Determination 2017/082

Regarding the compliance of a deck balustrade that forms part of the barrier to a swimming pool at 56 St Michaels Avenue, Point Chevalier, Auckland

Figure 2: Elevation showing gate and stairs (not to scale)

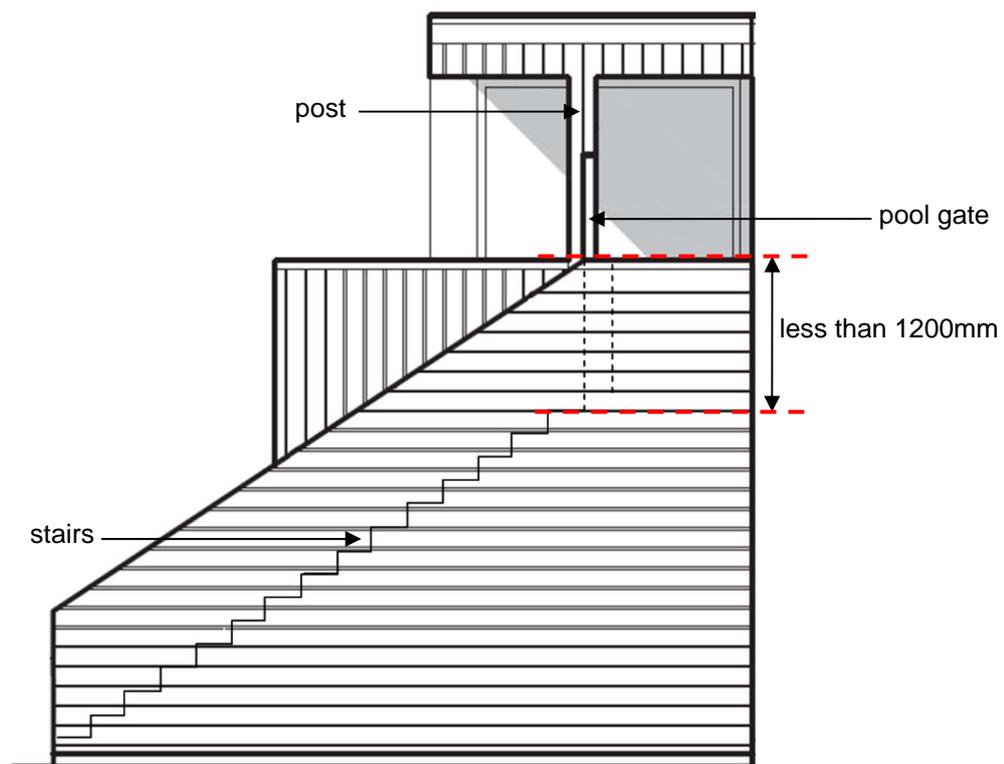
- 2.4 Drawings show the existing deck balustrade at 1000mm high. The gate is shown with a latch positioned 1550mm above the finished floor level of the landing and attached to a 100mm x 100mm post. The topmost stair and the edge of the landing are located less than 1200mm from the top of the balustrade as shown in Figure 2.

- 4.3.7 The floor of the deck, is for the most part, more than 2400mm vertically above the immediate pool area, with the exception of the adjacent external stairs where the topmost treads to the stair leading to the deck are less than 1200mm below the top of the balustrade (refer Figure 2).

- 4.3.9 I am of the view that paragraph 2.5.1 of F9/AS1 does not apply, regardless of whether the stairs are contemplated as part of the immediate pool area or as “projections” within 1200mm of the top of the balustrade. The risk to children is in climbing over the balustrade at a point where there is a height of less than 1200mm between the top of the balustrade and the upper steps or landing.

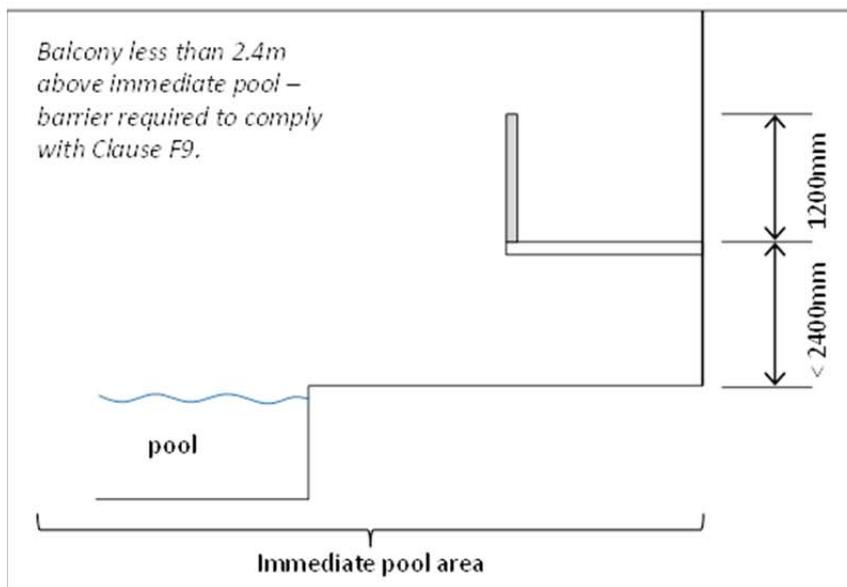
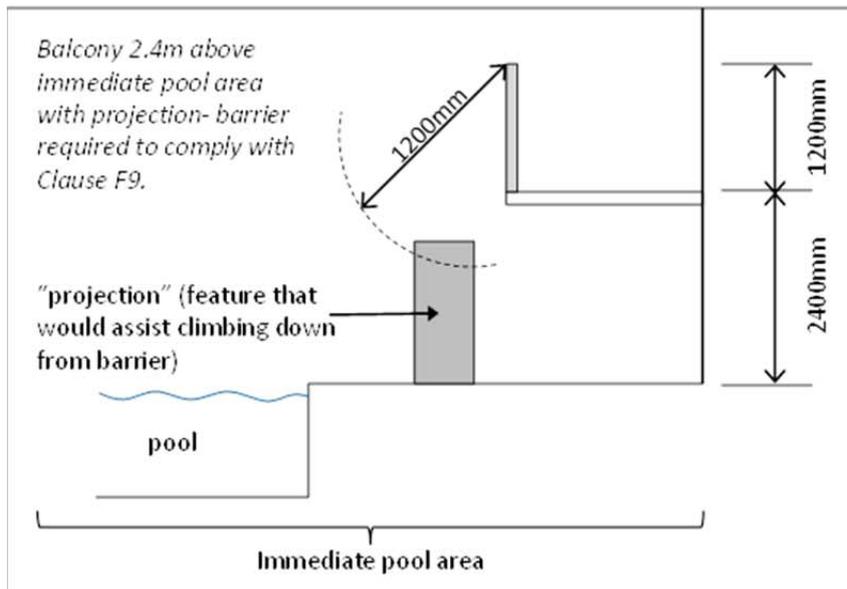
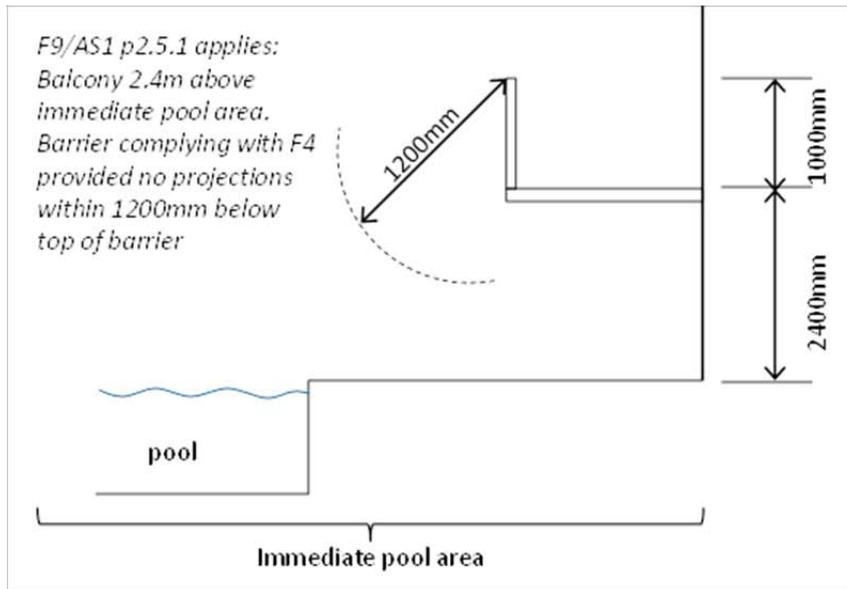
2.5.1 When the floor of a balcony is more than **2400 mm vertically above** the immediate pool area, a barrier complying with Clause F4 may be used instead of a Clause F9 barrier provided that there are...**no projections within 1200 mm below the top of it** (such as a wall or landscaping feature) that could assist a child to climb down.

- balconies sufficiently high (2400mm) above an immediate pool area only need a barrier of 1000mm in height (to comply with Clause F4) and not 1200mm (to comply with Clause F9); but this is only applicable where there are no “projections” (i.e. features that would assist a child climbing down from the balustrade) within 1200mm from the top of the barrier
- balconies 2400mm or more over an immediate pool area where there is a “projection” within 1200mm from the top of the barrier, will require a barrier that complies with Clause F9 to mitigate the risk of a child climbing down from the balcony barrier
- balconies less than 2400mm over an immediate pool area will require a barrier that complies with Clause F9.

- 4.3.6 Provided the deck in this case is 2400mm vertically above the immediate pool area and there are no projections with 1200mm below the top of the balustrade, it would comply with Clause F4 and would also comply with F9 by way of the Acceptable Solution. However, if the deck is less than 2400mm above the pool area, or if there are projections within 1200mm of the top of the balustrade, then paragraph 2.5.1 of F9/AS1 does not apply.

Figure 3: Approximate location of barriers (not to scale)

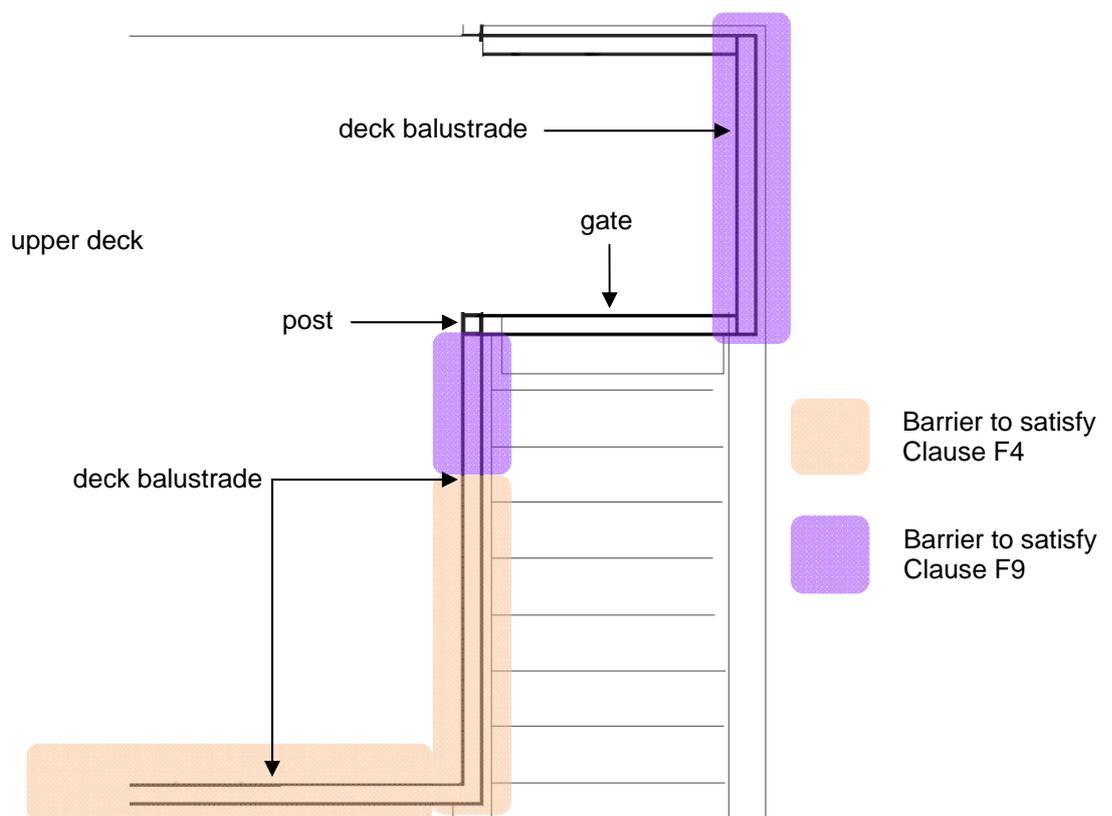
- 4.3.10 I am of the view that the ability of children to climb over the balustrade is exacerbated by the location of the gate.
- 4.3.11 I consider that the features of this design could assist a child to climb down into the immediate pool area, and accordingly the deck balustrade at 1000mm high does not meet the performance requirement of Clause F9.3.1 with respect to those areas adjacent the external stairs (as shown in Figure 3 below).

- 4.4.1 The upper deck is excluded from the immediate pool area, and as such the balustrade and gate are the physical barriers that must restrict the access of children into the immediate pool area.
- 4.4.2 The balustrade with a proposed height of 1000mm is insufficient to restrict access to the immediate pool area for those areas described in Figure 3, and as such it does not comply with Clause F9.3.1.

- 5.1 In accordance with section 188 of the Building Act 2004, I hereby determine that the proposed balustrade to the deck in some areas, as described in this determination, does not comply with Clause F9.3.1.
